Comparison Report

AC SOCKET (R-301SN(B298),RICH BAY)

AC SOCKET (R-301SN(B00)-Z,RICH BAY)

Package Dimension

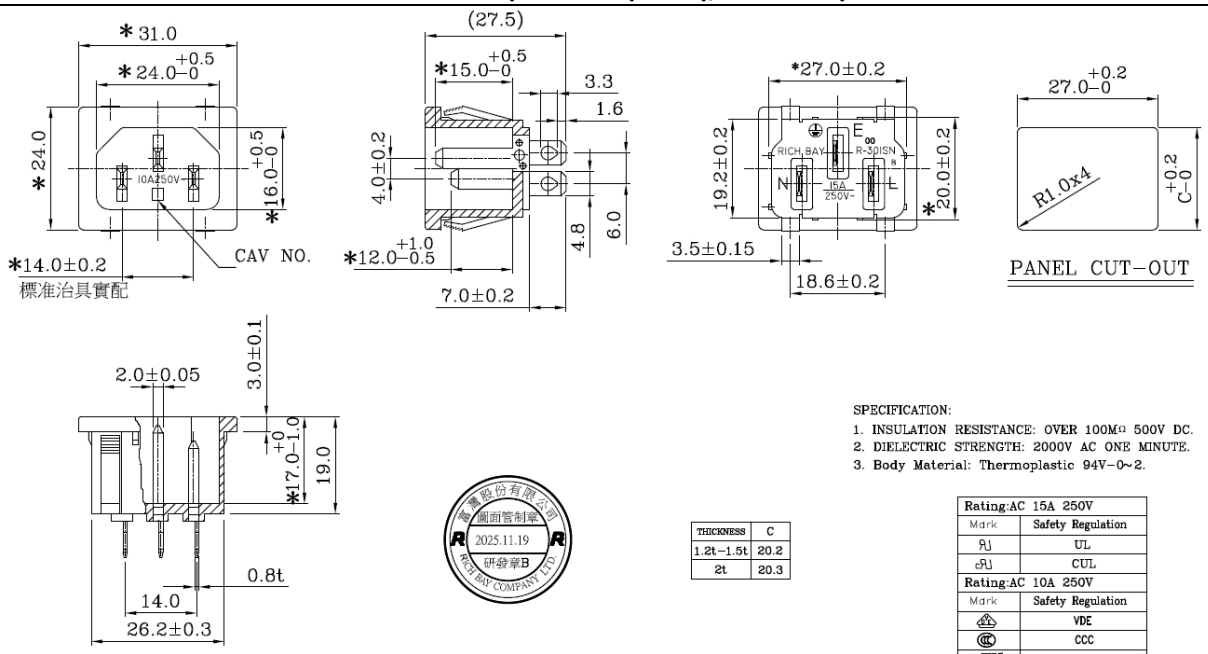
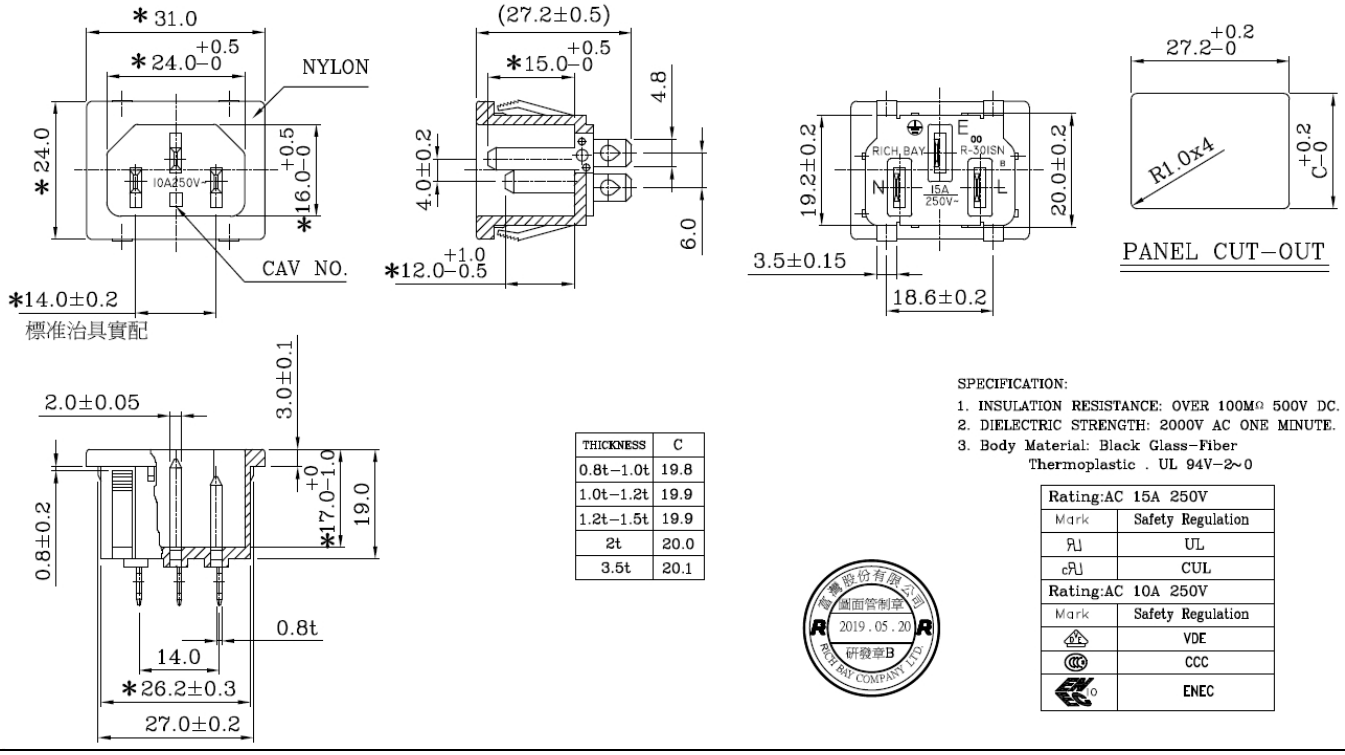
OLD ：3FM00300822

NEW : 3FM00300823

THICKNESS	C
0.8t−1.0t	19.8
1.0t−1.2t	19.9
1.2t−1.5t	19.9
2t	20.0
3.5t	20.1

SPECIFICATION:
1. INSULATION RESISTANCE: OVER 100MΩ 500V DC.
2. DIELECTRIC STRENGTH: 2000V AC ONE MINUTE.
3. Body Material: Black Glass−Fiber Thermoplastic . UL 94V−2~0

Comparison Report

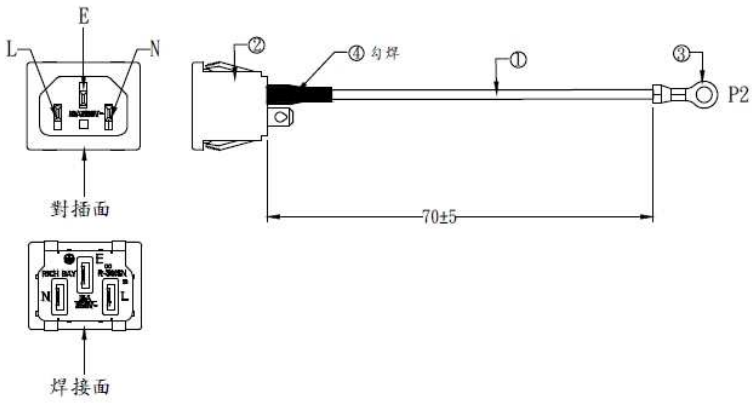
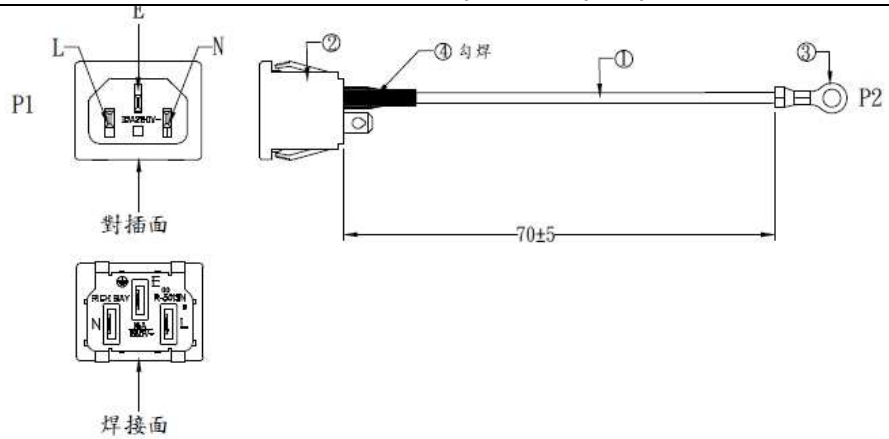
OLD ：3KH0007734A

NEW : 3KH0007734B

AC SOCKET(R-301SN(B00)-Z &GND WIRE,YOMIN

PICTURES

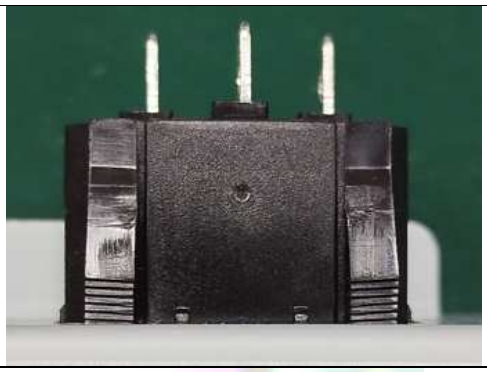
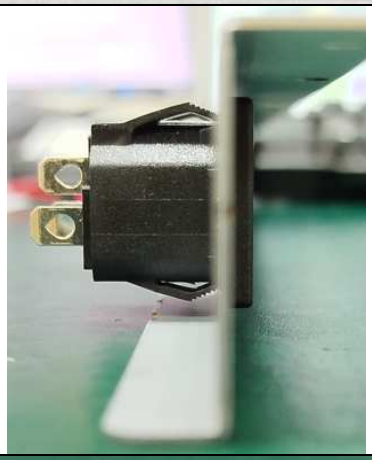
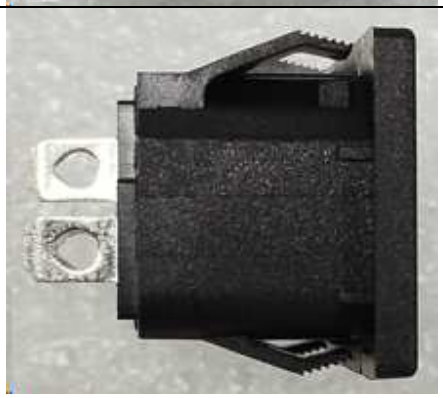
Item	OLD ：3FM00300822 AC SOCKET (R-301SN(B00)-Z,RICH BAY)	NEW：3FM00300823 AC SOCKET (R-301SN(B00)-Z,RICH BAY)
Front View		
Top View

Comparison Report

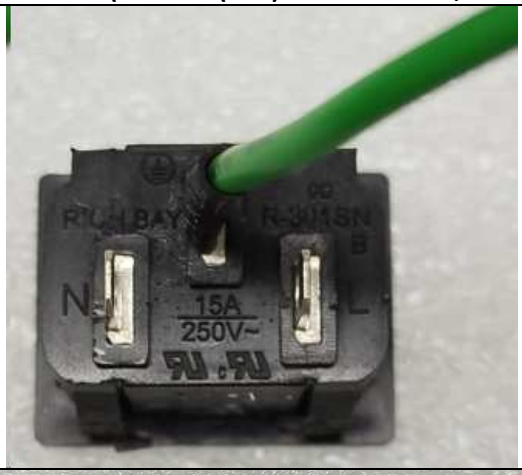
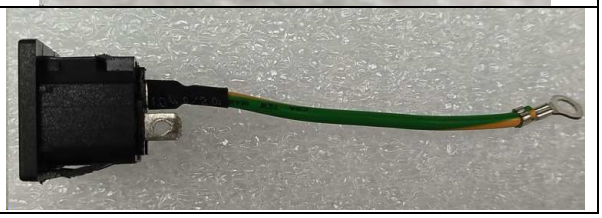
Item	OLD ：3KH0007734A AC SOCKET(R-301SN(B298))&GND WIRE,YOMIN	NEW ：3KH0007734B AC SOCKET(R-301SN(B00)-Z &GND WIRE,YOMIN
Back View

This noncritical component change has been evaluated by DIVA; the initial successor evaluation showed the new successor is compatible with former model. None of the other components and program will be needed to recalibrate or implement. The ECN will be provided if you approve.
